Job No. 2021/1332

RE: Response to Submission – Westgate Industrial Estate (Item 15 - Fire Fighting Perimeter Access Roads (SSD-23480429))

Attachment A

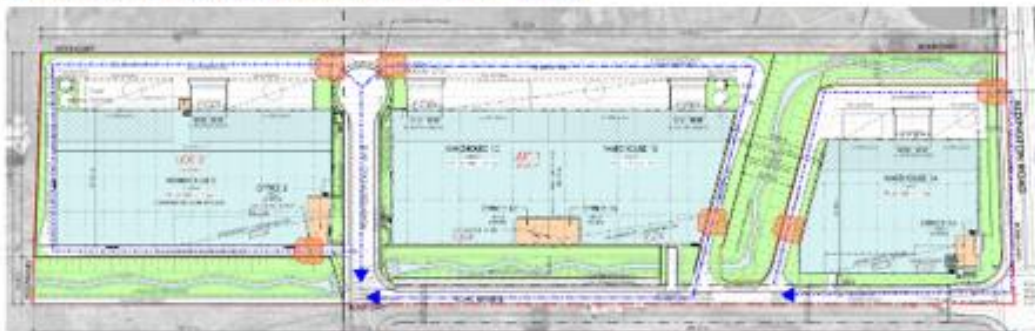
Item	Non-Compliance	DTS Clause	Description	Performance Requirement
3.	Requirements for open spaces and vehicular access	C3D5	<p>The following departures associated with the perimeter vehicle access are to be addressed:</p> <ul style="list-style-type: none"> The vehicular perimeter access road is situated greater than 18m to the following areas: <ul style="list-style-type: none"> Up to 21m to the North of each warehouse in isolated instances] Up to 19m to the East of Warehouse 1A (Aldington Road); Up to 32m to the South of Warehouse 1b & 1 C; Contains portions of the perimeter access road of a clear width of less than 6m as per the following: <ul style="list-style-type: none"> Reduced to 4.9m along the south and western elevations of warehouse 2 for the length of the elevation in parts due to obstructions. Reduced to 5.6m due to the gates located on the North-Eastern corner of Warehouse 1A. Security gates are also proposed to cross the vehicular access path where the vehicular access road connects to the public road. 	C1P9

Obstructions within the perimeter vehicle path – Gates

6m perimeter path deviations – Path Exceeds 18m

Perimeter Vehicle Path where 6m width is not achieved
